RE: **Lot 7-A-1 6-A-1 Block 9 Unit 18 SAD 228**
6536 Papagayo NW
Volcano Cliffs Subdivision
Grading and Drainage Plan
Engineers Stamp Date 7/25/18 (D10D003I7)

DRAINAGE AND TRANSPORTATION INFORMATION SHEET (REV 6/2018)

RE: **Lot & A-1 & A-1 Block 9 Unit 19 SAD 228
6536 Papagayo NW
Volcano Cliffs Subdivision
Grading and Drainage Plan
Engineers Stamp Date 7/19/18 (D10D003I7)**

ENGINEER'S SEAL	Title 6536 PAPAGAYO NW	DRAWN BY
	GRADING AND DRAINAGE PLAN	DATE
7/25/18	RHD Engineering, LLC 4305 Purple Sage Ave. NW ALBUQUERQUE, NM 87120 (505) 288-1621	SHEET # 1 of 1
Richard Dourte P.E. #10854		JOB #

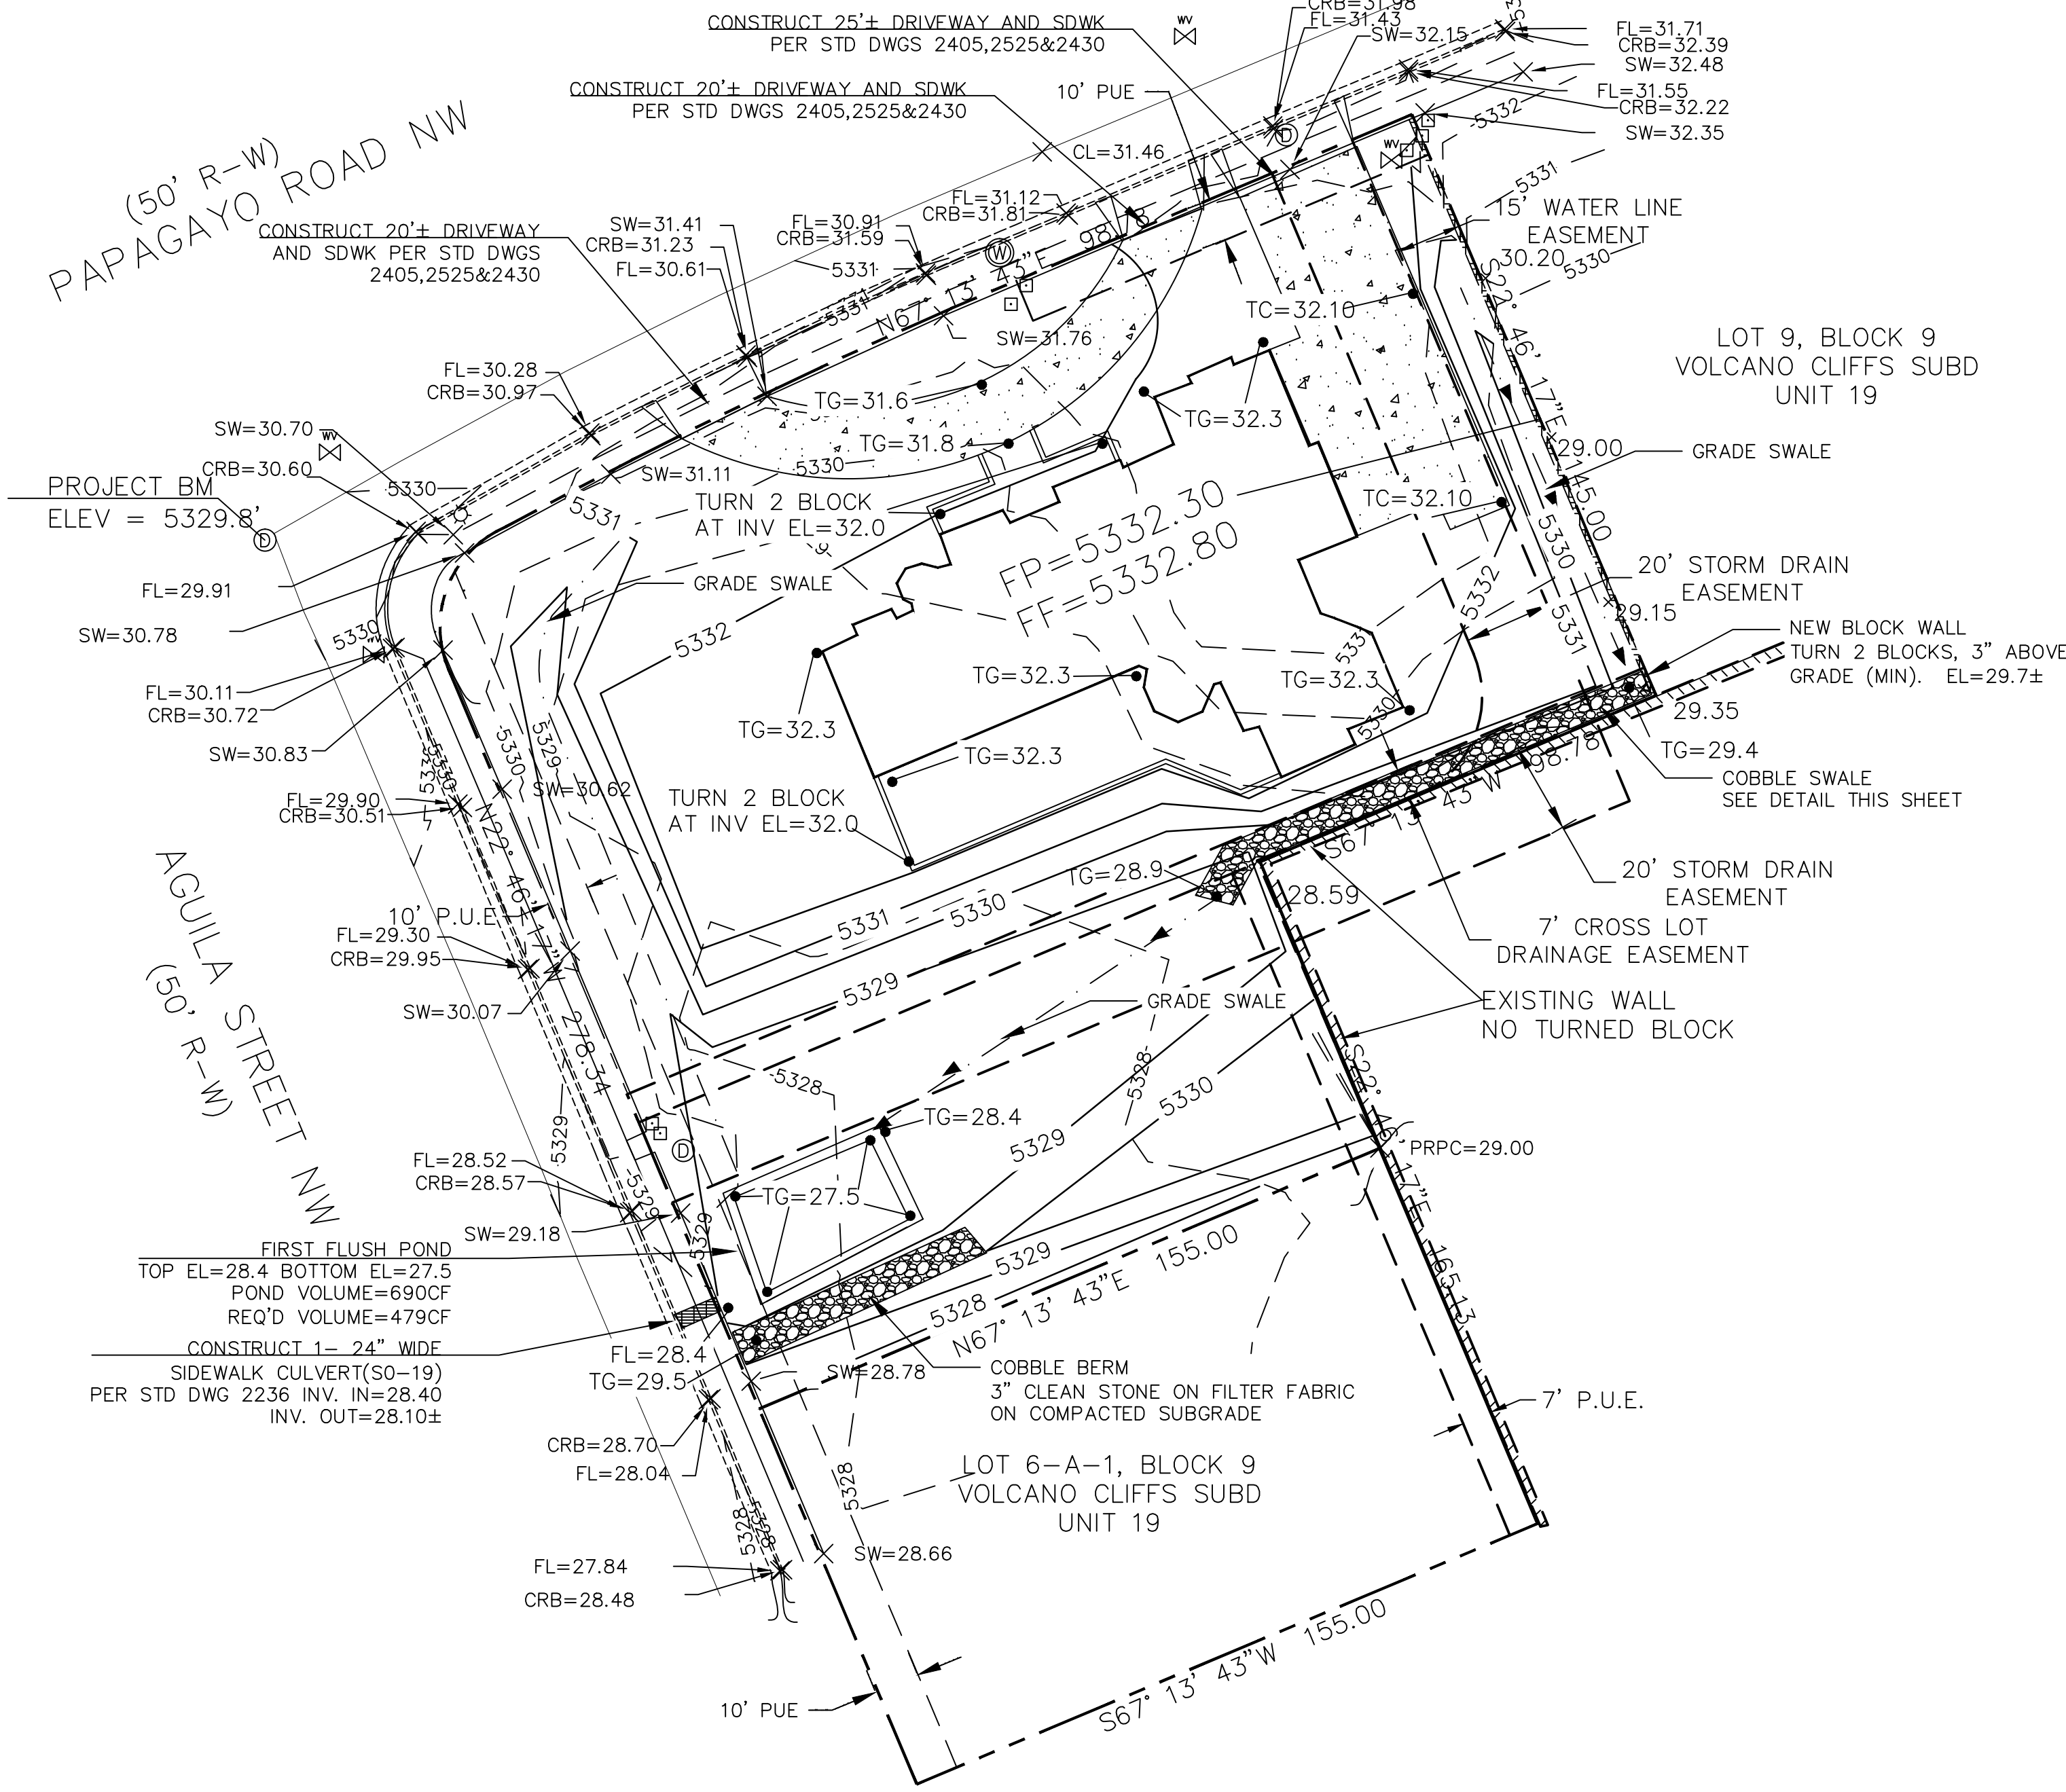
- In the cross section of the retaining wall show the location of the footing. If encroaching into adjacent lots a written letter of approval from the owner of the adjacent lot is required.
- Show the SS easement crossing between lots 6A & 7A. Construction is prohibited in the SS easement. A garden wall must not be built on top of the SS line. If the owner wishes to build near the SS, advise the owner, if the SS needs to be worked on or replaced, the garden wall may be removed or damaged and the owner will replace the wall at their cost, not at the cost of the COA.

1. The cross section now shows the foundation for the wall to be contained onsite with a note "Footing for wall to be located onsite, otherwise a written letter of approval from adjacent/impacted property owner is required"
2. The storm sewer easement is clearer on the drainage plan. A copy of the recent replat has been included for your convenience. Presently there is a substantial retaining wall located on the property line between this site and the existing subdivision south of this site. The linework for this wall has been redone. No new walls are proposed to be placed on the existing 20' storm drain easement.
